# ADDENDUM No. 1

## RFP No. 23-59

### East Medical Center Drive Bridge Rehabilitation and Widening Project

**SECTION AT PIER 2**

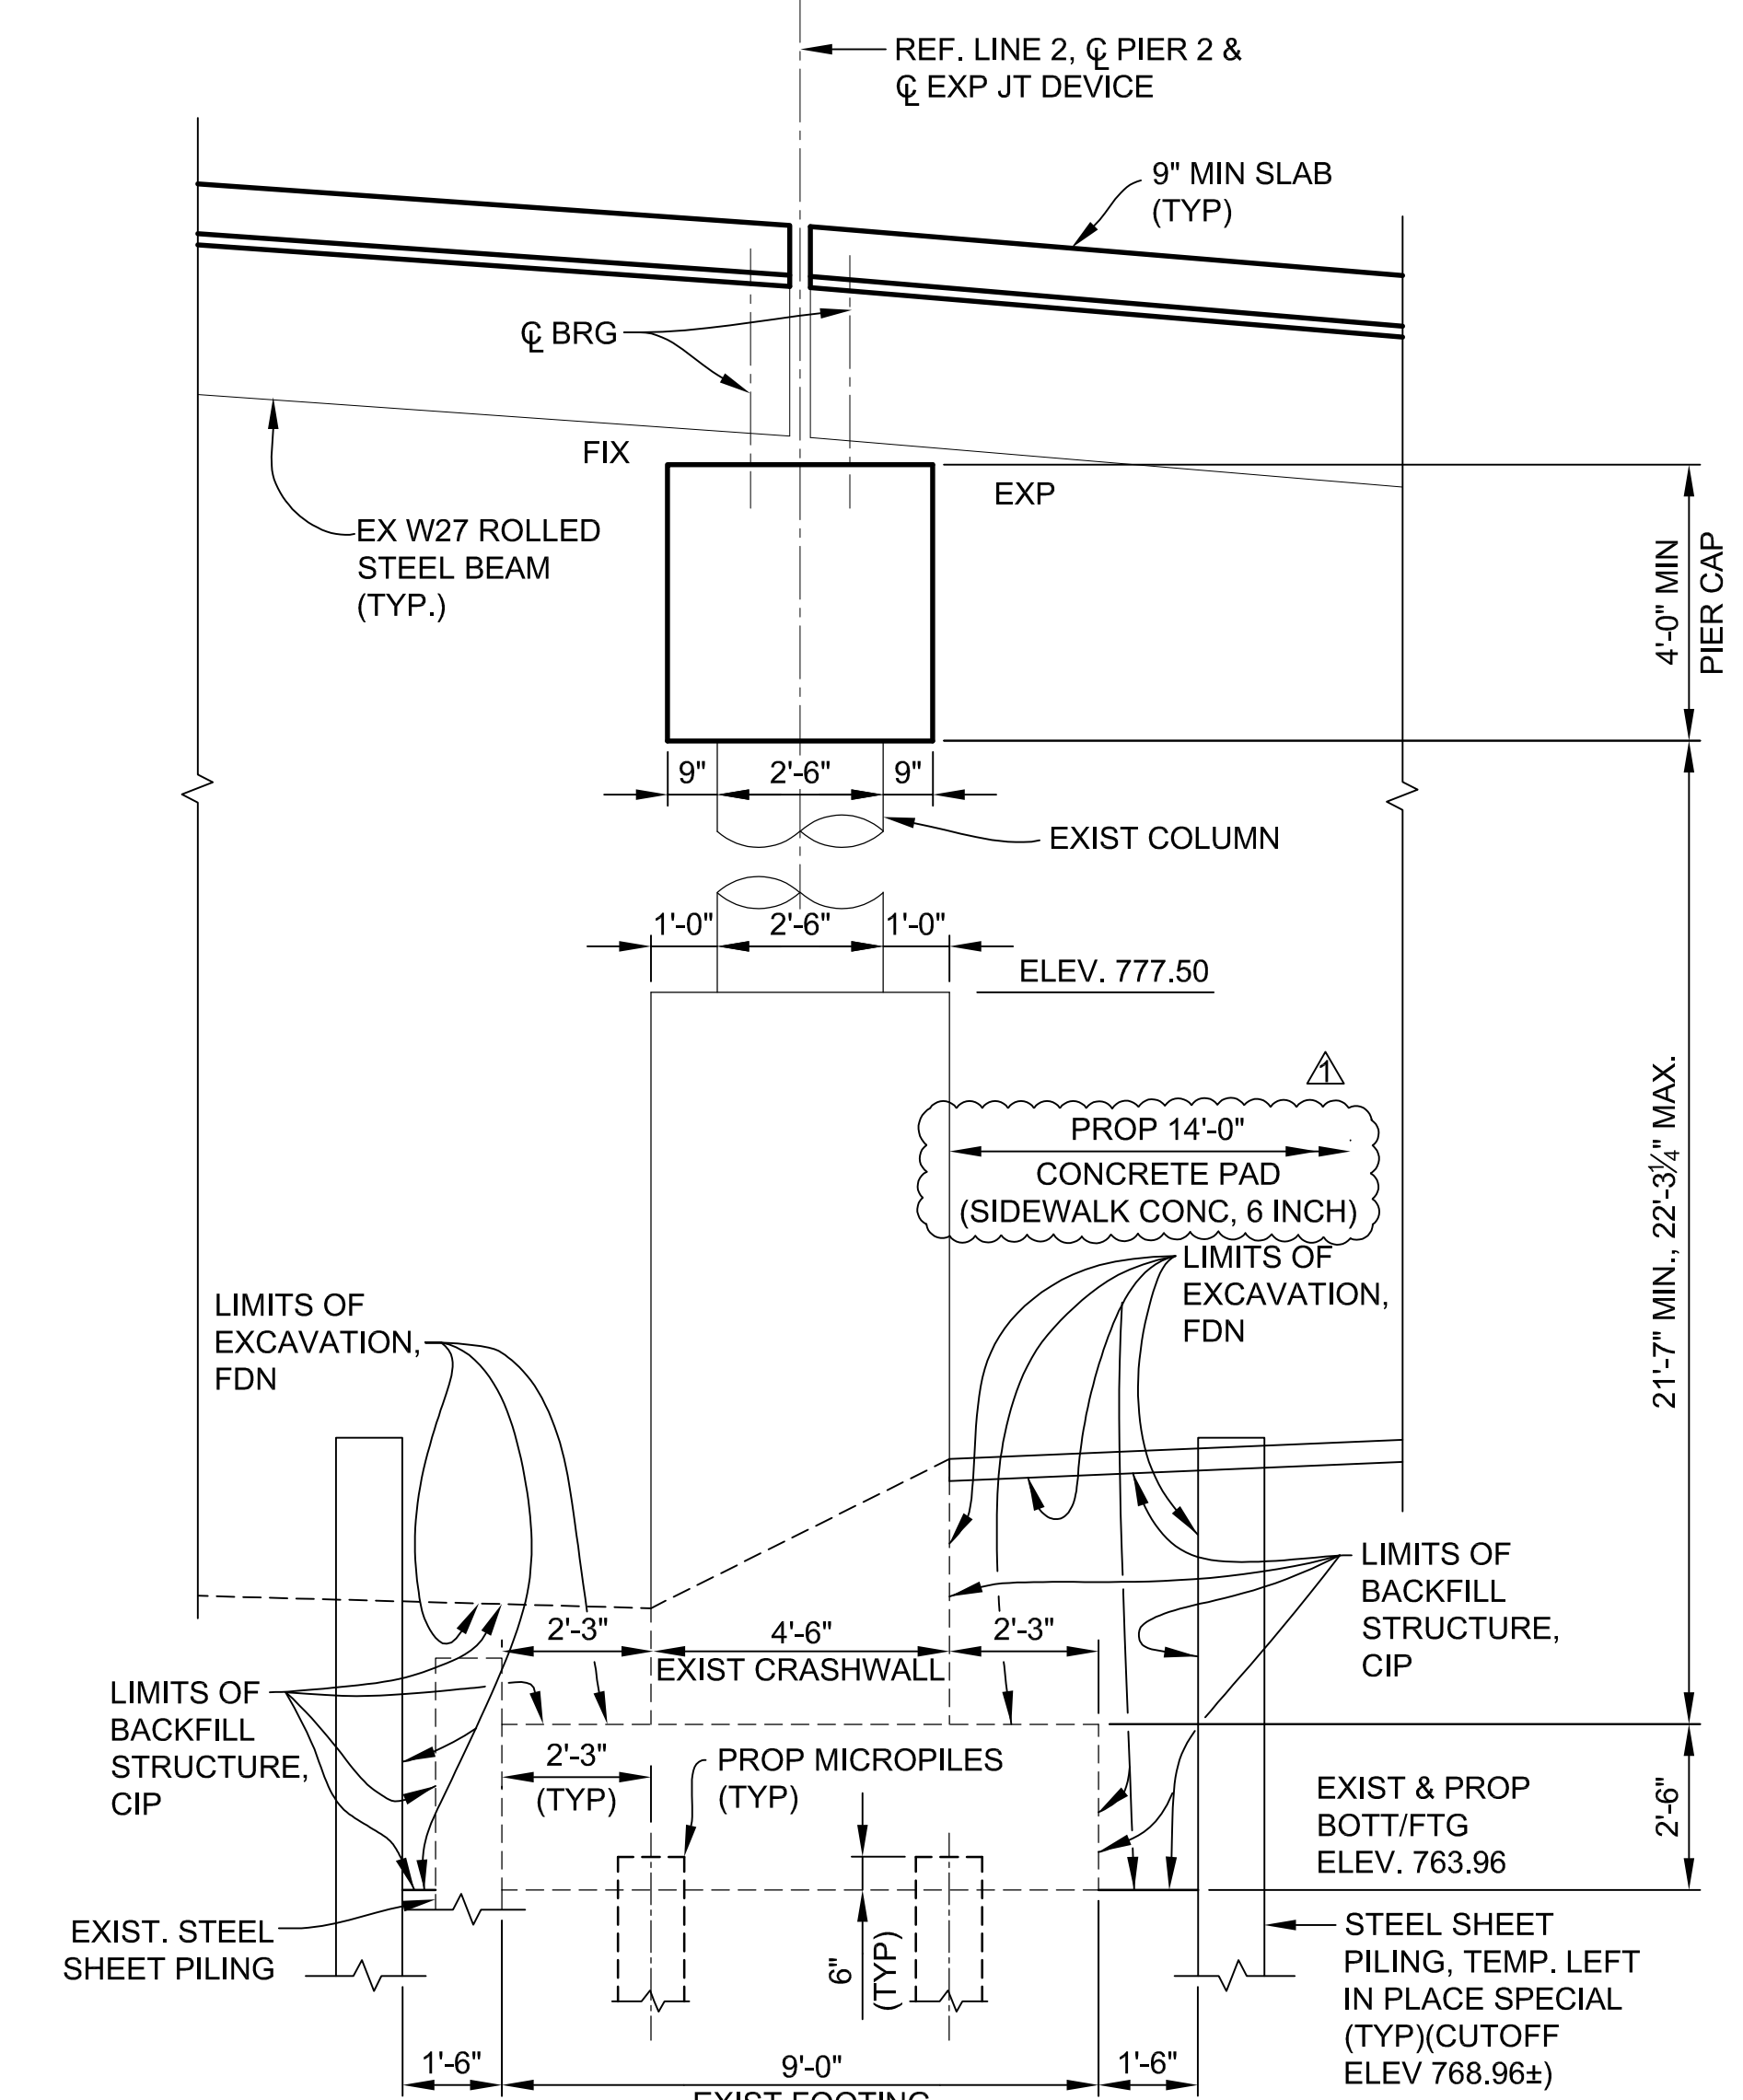
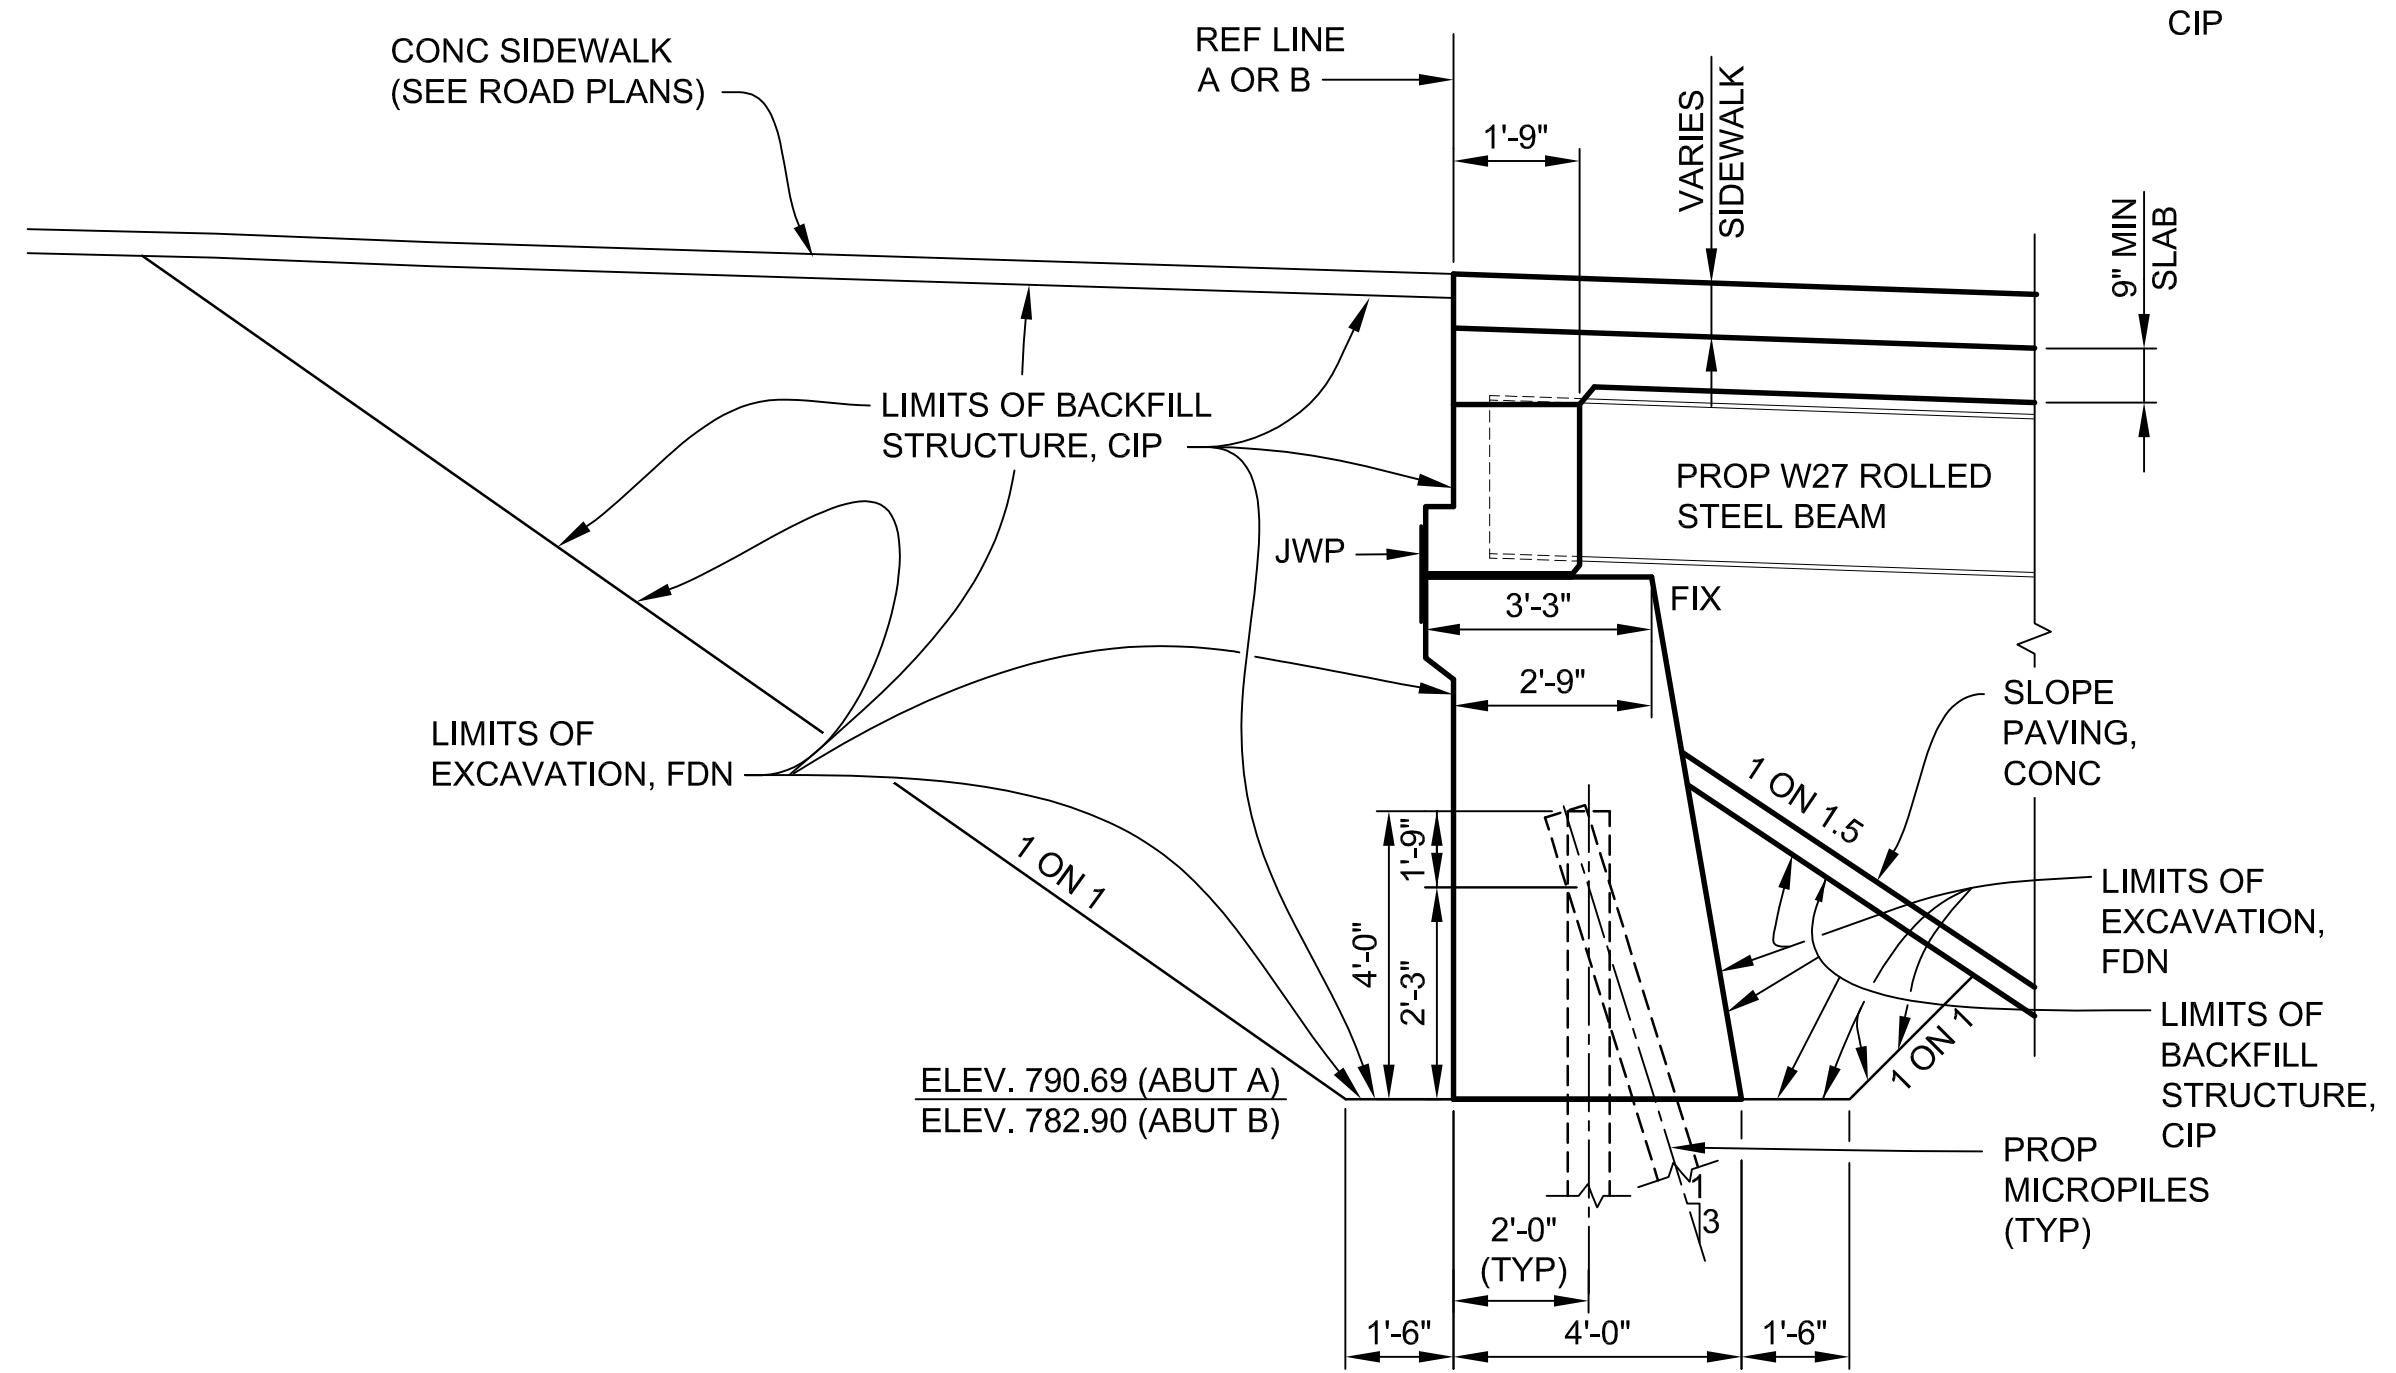
- Answer 7: The cost of the Track Inspector will be paid for by the City.
- Question 8: Drawing sheet 69 of 155 notes "Exist Permanent Steel Sheeting" at piers 1 and 2. The drawing infers that there is existing sheeting around the pier extension. The drawing shows "Steel Sheet Piling, Temp Left In Place" at the same location. Drawing 80 of 155 also details the 2 rows of sheeting. Please clarify.

- Answer 8: The drawing has been revised to show the existing sheeting only around the existing footing.
- Question 9: The drawing on sheet 69 shows 360 Sft of "Steel Sheet Piling, Temp" in the quantity table. Where is this item utilized in the plans?

Question 24: There exists several areas of concrete removal required for the construction of permanent works that are not specifically called out on the plans. These include the concrete slope paving in the area of the soil nails, permanent sheet pile walls and the pier wall extensions. There is also a concrete slab /walkway next to Pier 2 that will require partial removal in order to construct the footing extension. Will this removal be paid for under Bid Item 2047011 Sidewalk and Drive, Any Type or Thickness, REM? Please clarify how this work will be paid for.

- Answer 9: The "Steel Sheet Piling, Temp" pay item is meant to be used at the staging line at each abutment. A call out has been added to the plan view on the General Plan of Structure sheet.

Answer 24: The concrete slope paving for the soil nail walls, and the existing concrete slab behind pier 2 are already called out in the note for the removal pay item on sheet 69. The conc slope paving behind pier 1 for the soil nail walls should be paid for under the "Structure Rem, Portions" pay item as well. The note has been updated to include that.
